Detailed Site Plan Harmony at Brandywine

DSP-20014

SUBJECT: Detailed Site Plan DSP-20014
Type 2 Tree Conservation Plan TCP2-036-2020
Harmony at Brandywine

Figure 2: Perspectives of the Front/North Elevation

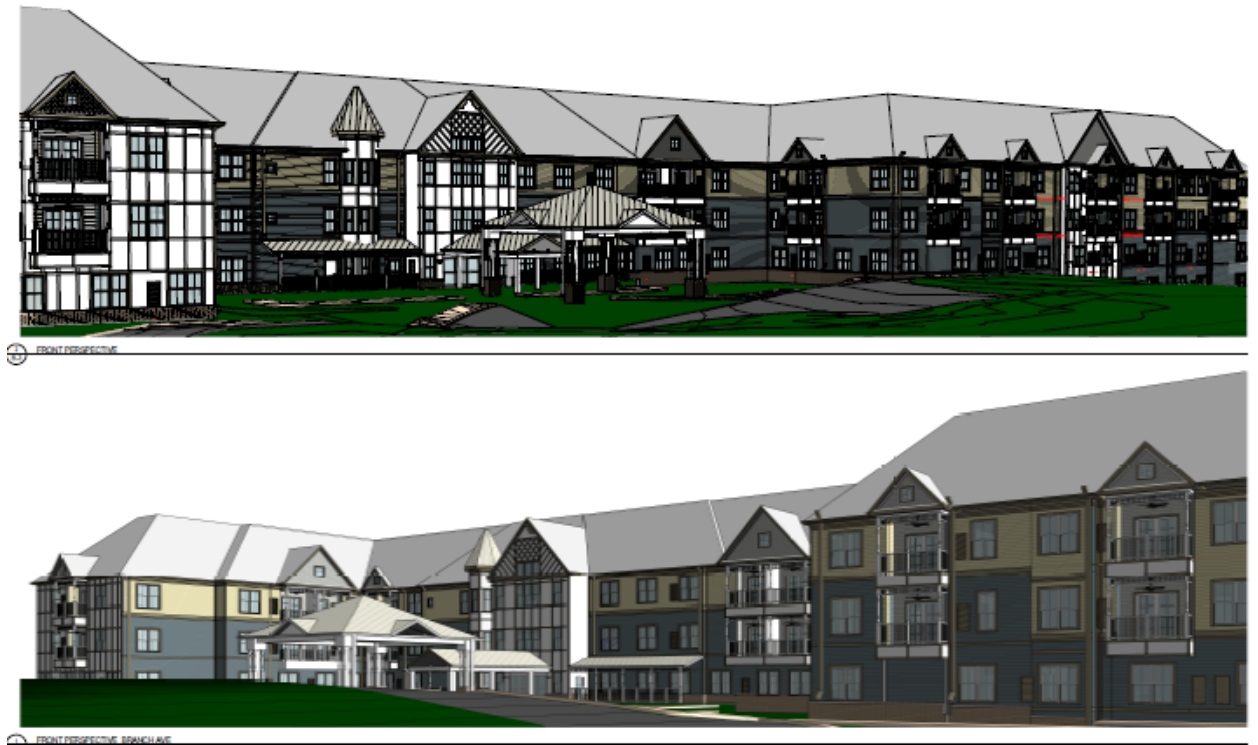
The applicant has submitted architecture with this DSP for the four-story, 54-foot-tall building. The main entrance will be highlighted with a patterned gable on the roof and a turret. Covered porches and the drop-off area canopy further highlight the main entrance. The rest of the front façade is made up primarily of two tones of brick and open balconies with Victorian detailing, topped with gabled roofs, which will provide vertical breaks in the building mass. The north end of the front façade introduces blue and yellow fiber cement siding on the upper stories. The rear and sides of the building are composed mostly of the fiber cement siding, with white vertical bays of windows also topped with gabled roofs.
